VAPOUR PROOFING PILE & PANEL WALL

MULTIPLEX
Built to outperform.

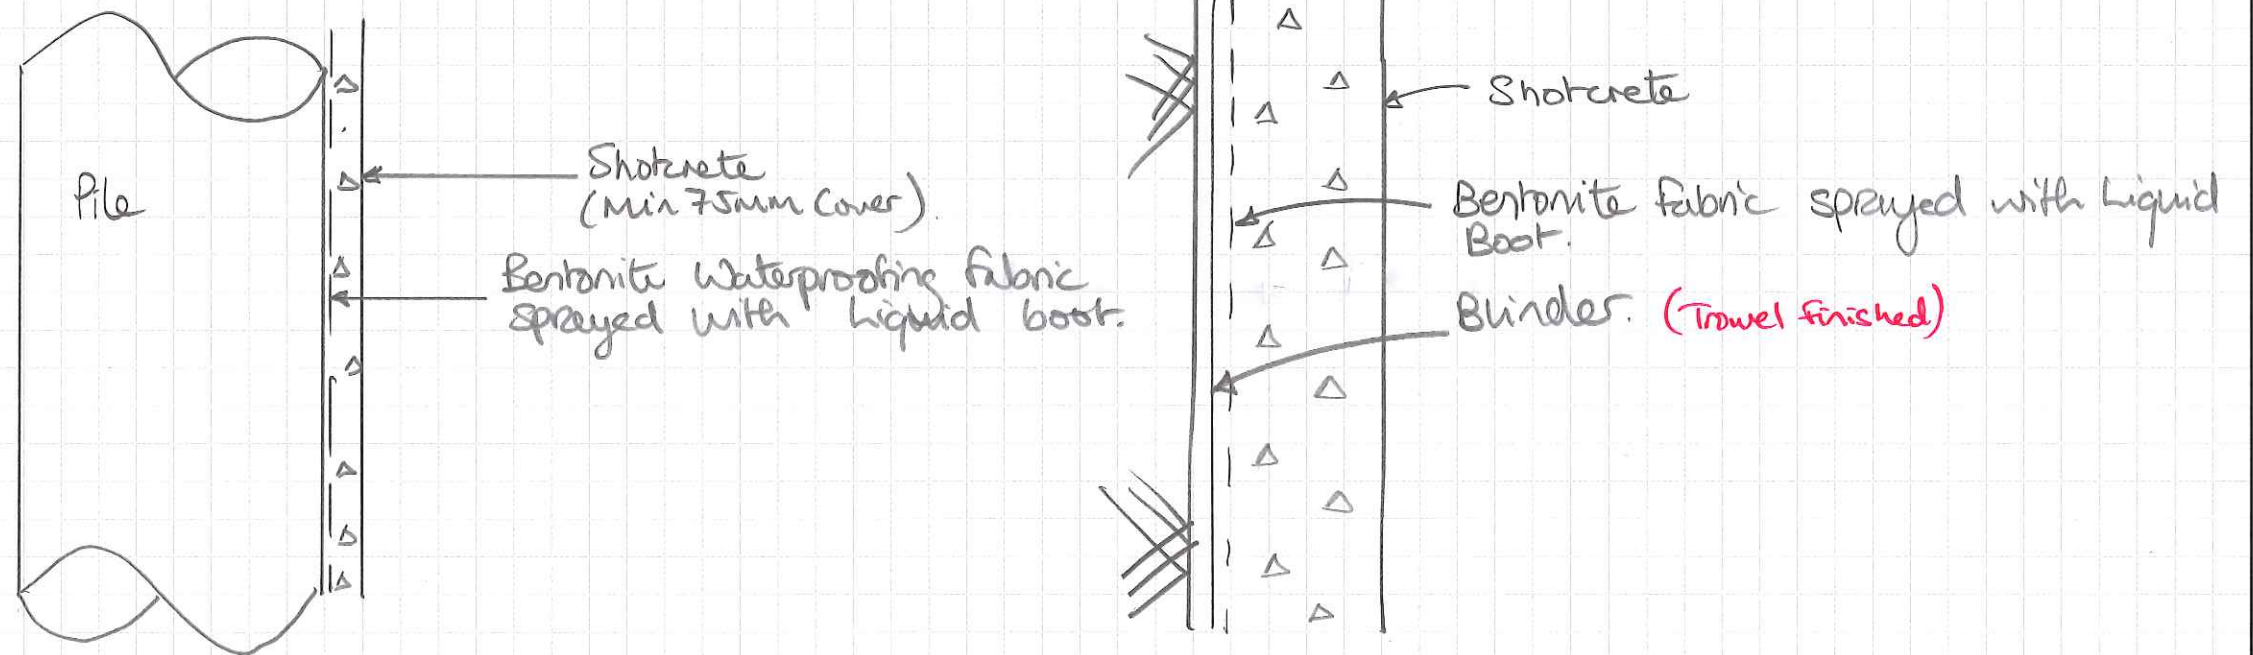
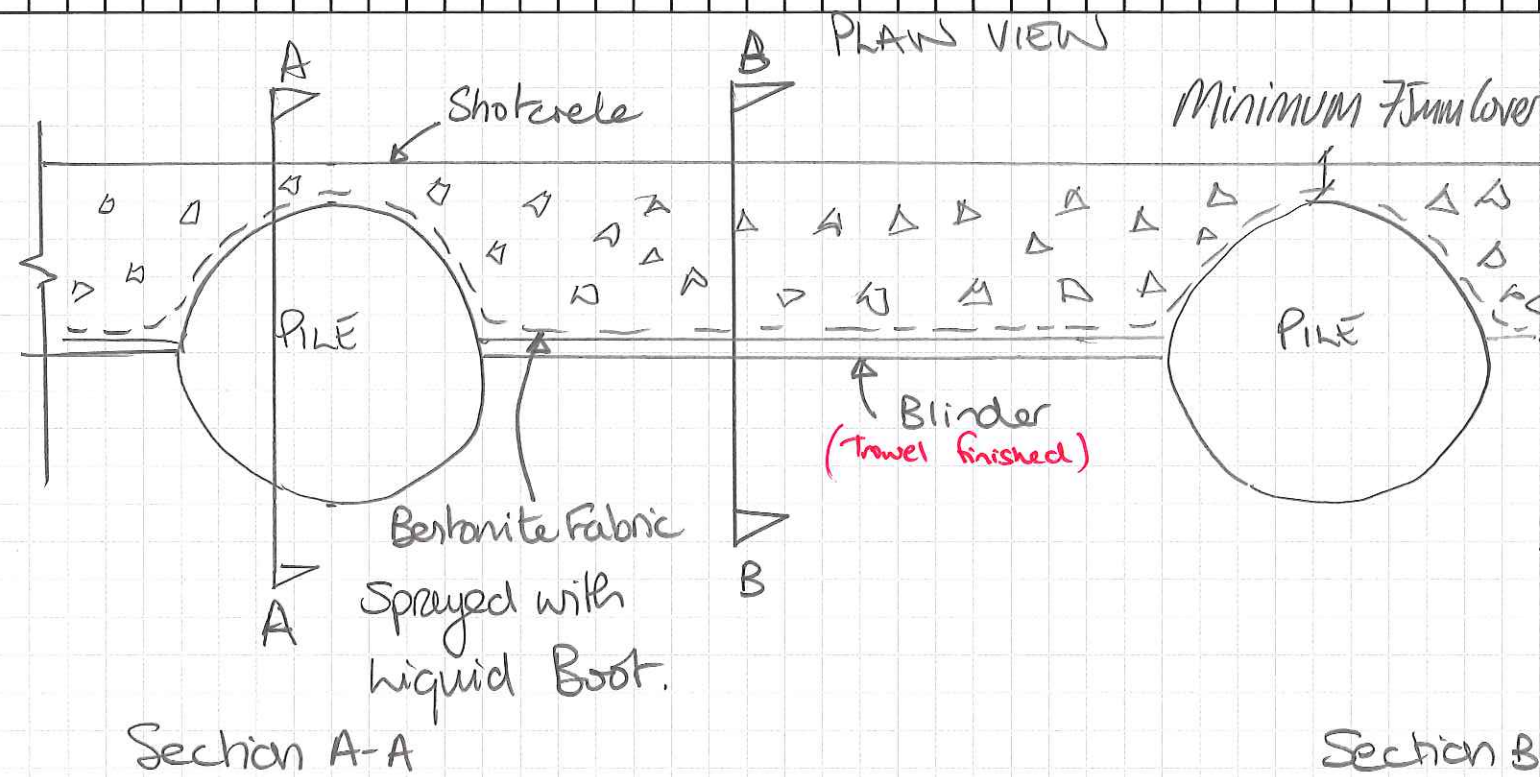
CETCO Recommend that vapour proofing is taken up to capping beam this is greater than was described by Suzanne from Butlers.
